Access Compliance Report Public Rights-of-Way (Curb Ramps)

Main Street: CAMERONS_WAY Cross Street: CRAFTSBURY_PL Location: NE

ADA ID: RPAT211102155509 Ramp Type: Type 4 - Parallel Initial Pass/Fail: Fail Overall Compliance: No Severity Score: 30

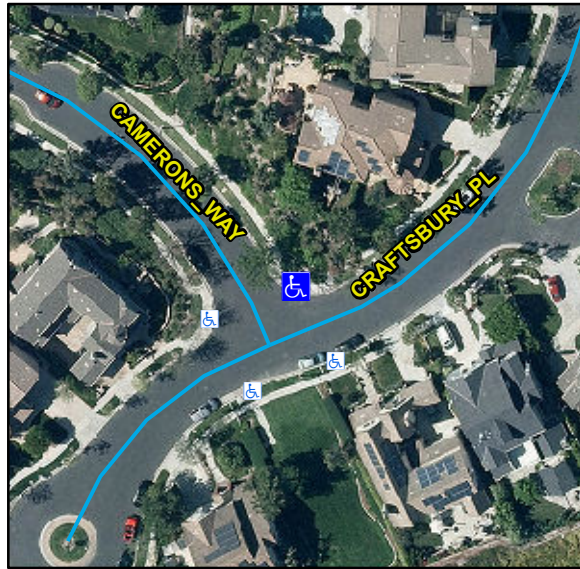
Compliance	Description	Data	Compliance	Description	Data
N/A	Ramp Length LT (in)	87	N/A	Ramp Length RT (in)	93
Yes	Ramp Width LT (in)	50	Yes	Ramp Width RT (in)	53
Yes	Ramp Run Slope LT (%)	0.4	No	Ramp Run Slope RT (%)	13.8
Yes	Ramp Cross Slope LT (%)	1.1	Yes	Ramp Cross Slope RT (%)	0.6
N/A	Landing Present	N/A	N/A	DWS Provided	N/A
N/A	Landing Length (in)	N/A	N/A	DWS Contrast	N/A
N/A	Landing Width (in)	N/A	N/A	DWS Length (in)	N/A
N/A	Landing Run Slope (%)	N/A	N/A	DWS Full Width	N/A
N/A	Landing Cross Slope (%)	N/A		DWS Offset Type	N/A
N/A	Landing Movement Obstructed?	N/A	N/A	DWS Offset Left (in)	N/A
	Landing Movement Type	N/A	N/A	DWS Offset Right (in)	N/A
N/A	Landing Shared	N/A			
N/A	Clear Space	Yes			
N/A	Clear Space To Crosswalk (in)	N/A			
N/A	Marked Crosswalk 1	No	N/A	Marked Crosswalk 2	No
	Crossing 1 Direction	W		Crossing 2 Direction	S
	Marked Crosswalk 1 Width (in)	N/A		Marked Crosswalk 2 Width (in)	N/A

Remove & Replace Curb Ramp With Two New Directional Ramps or Equivalent.
